MINOR AMENDMENT TO PD PLAN FOR PLAT 4 DISCOVERY PARK SUBDIVISION

LOCATED IN SECTIONS 32 & 33, TOWNSHIP 48N, RANGE 12W
BOONE COUNTY, MISSOURI
APRIL, 2018

Project Number: 80318014-00; CITY OF COLUMBIA #16-173

SHEET NAME
OVERALL DEVELOPMENT PLAN

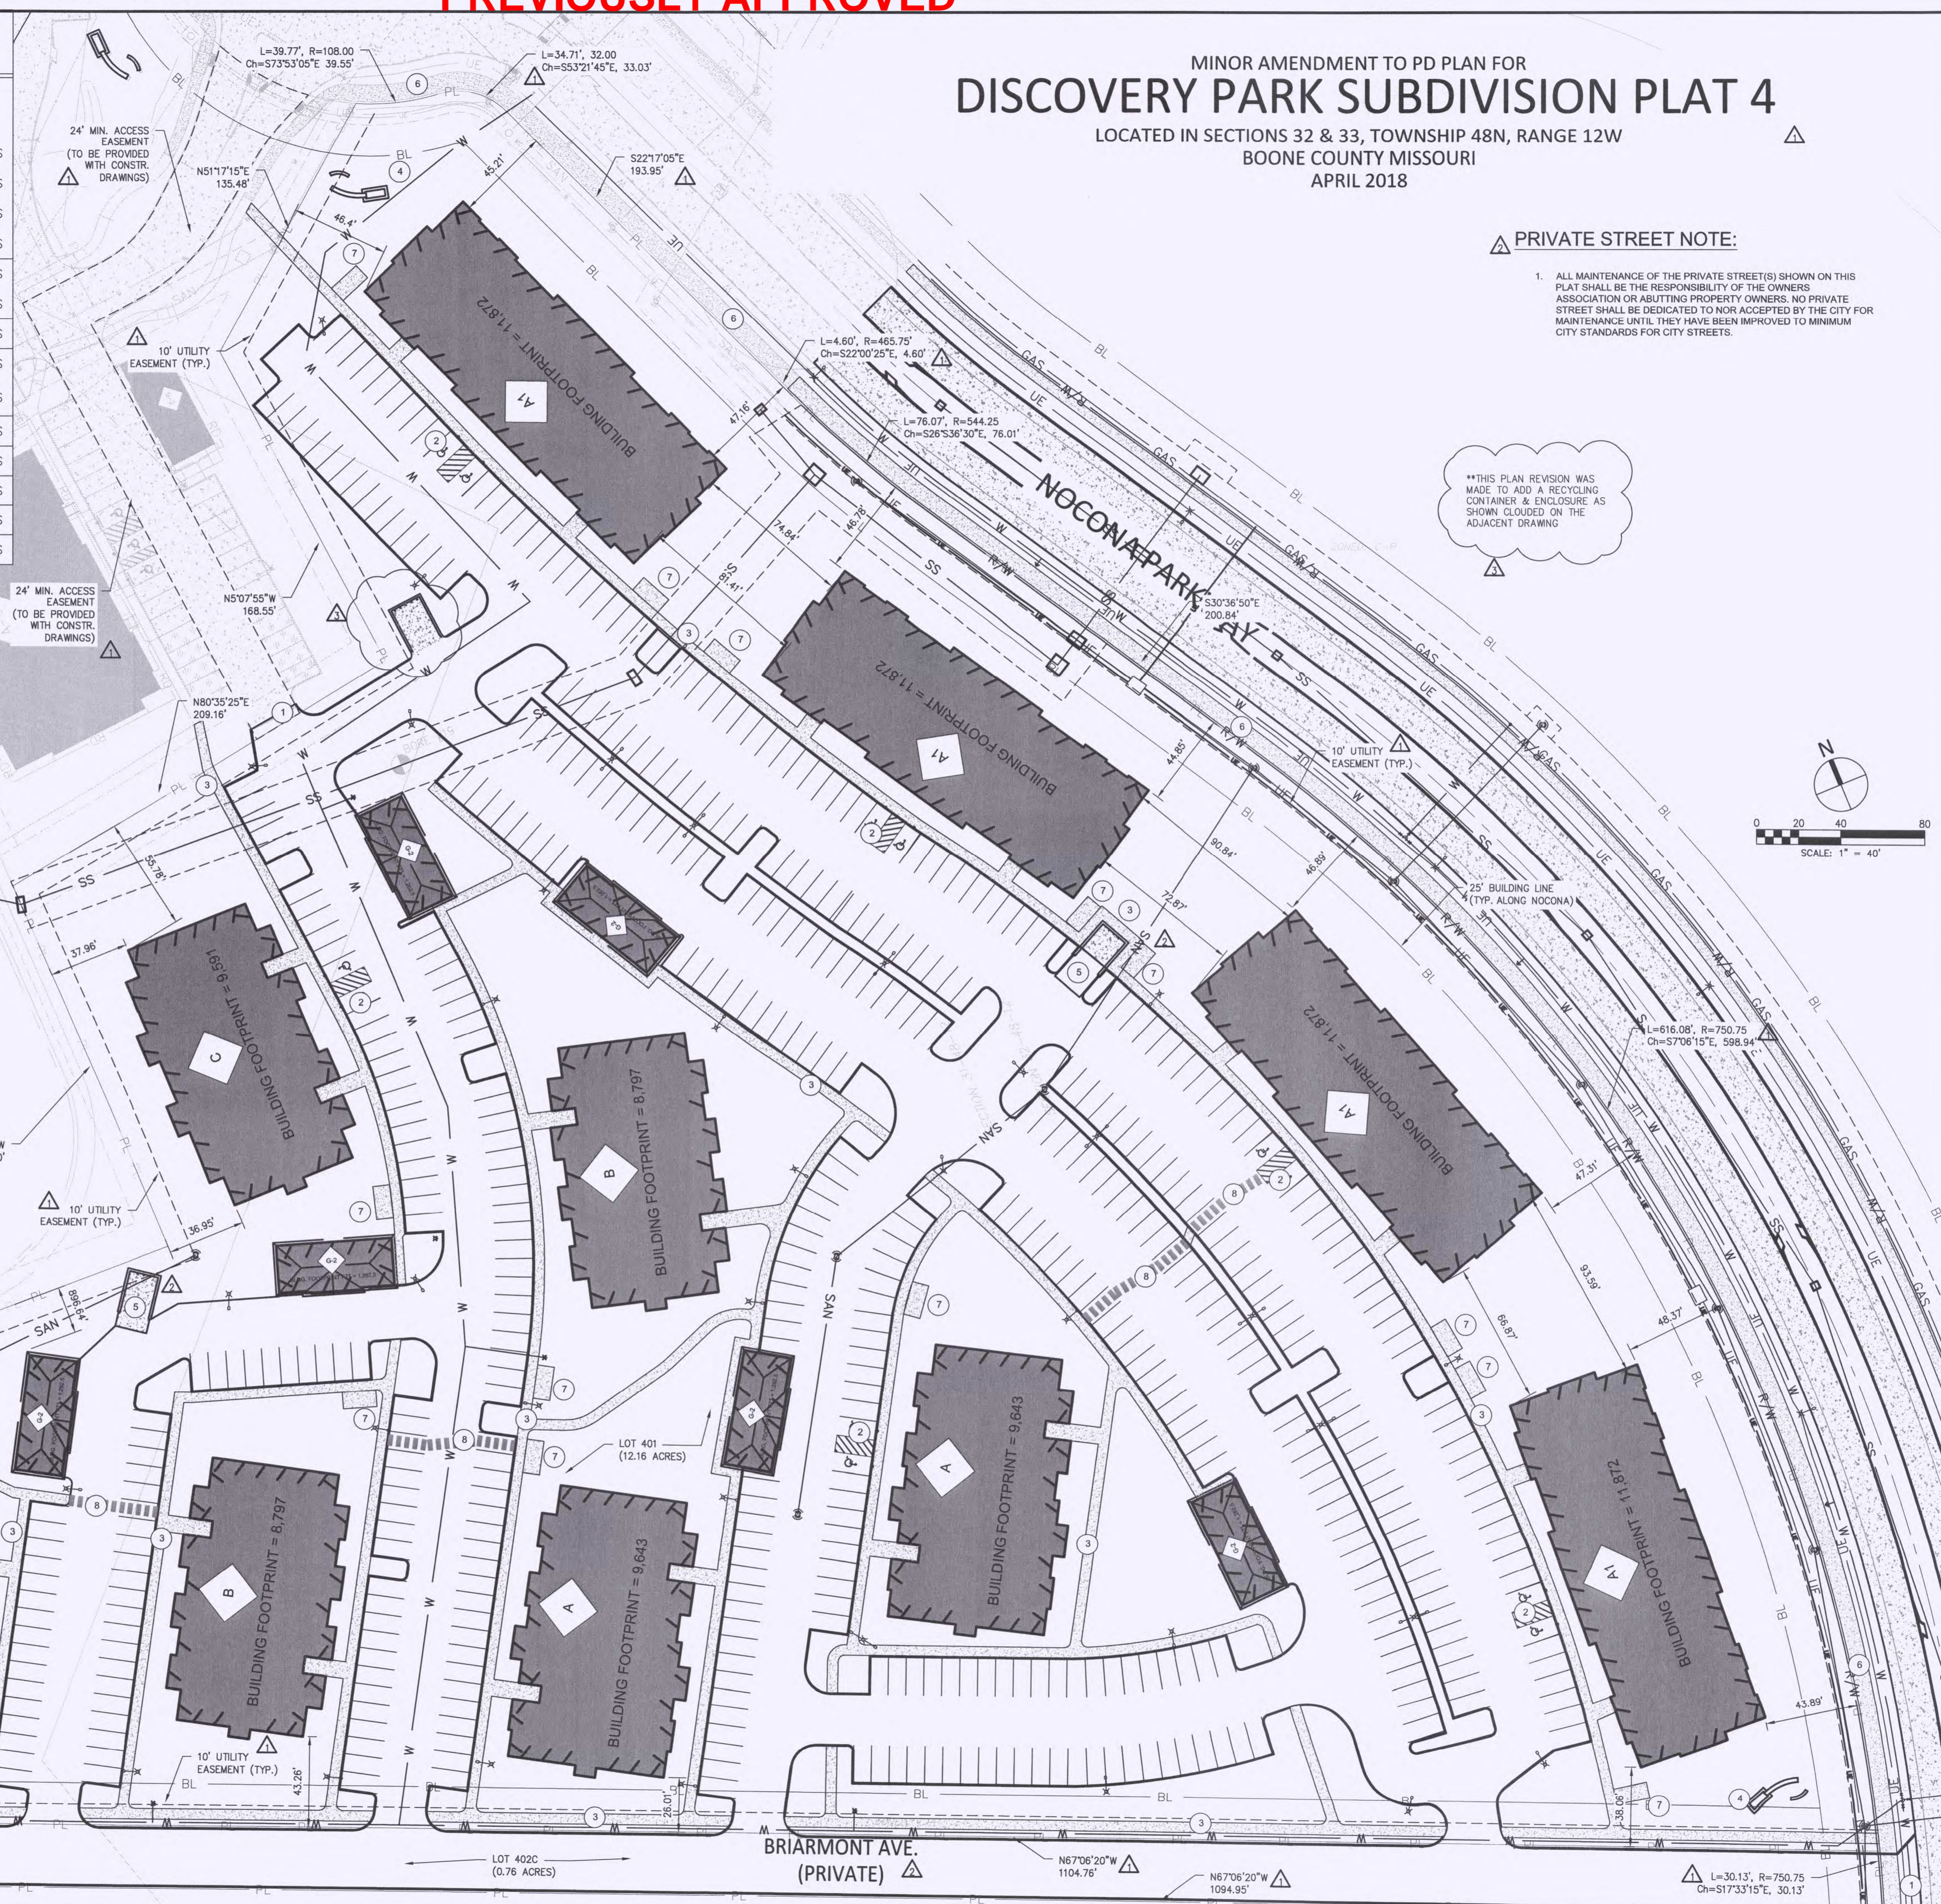
**THIS PLAN REVISION WAS MADE TO ADD A RECYCLING CONTAINER & ENCLOSURE AS SHOWN CLOUDED ON THE ADJACENT DRAWING

SHEET NAME
PD PLAN

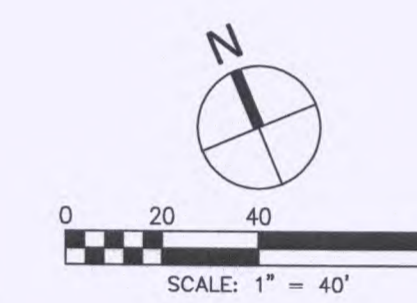
**THIS PLAN REVISION WAS MADE TO ADD A RECYCLING CONTAINER & ENCLOSURE AS SHOWN CIRCLED ON THE ADJACENT DRAWING

SHEET NAME
PD PLAN &
LANDSCAPING
CONCEPT

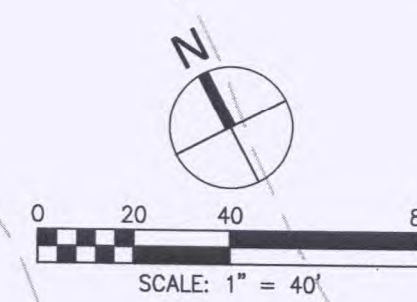
**THIS PLAN REVISION WAS MADE TO ADD A RECYCLING CONTAINER & ENCLOSURE AS SHOWN CLOUDED ON THE ADJACENT DRAWING
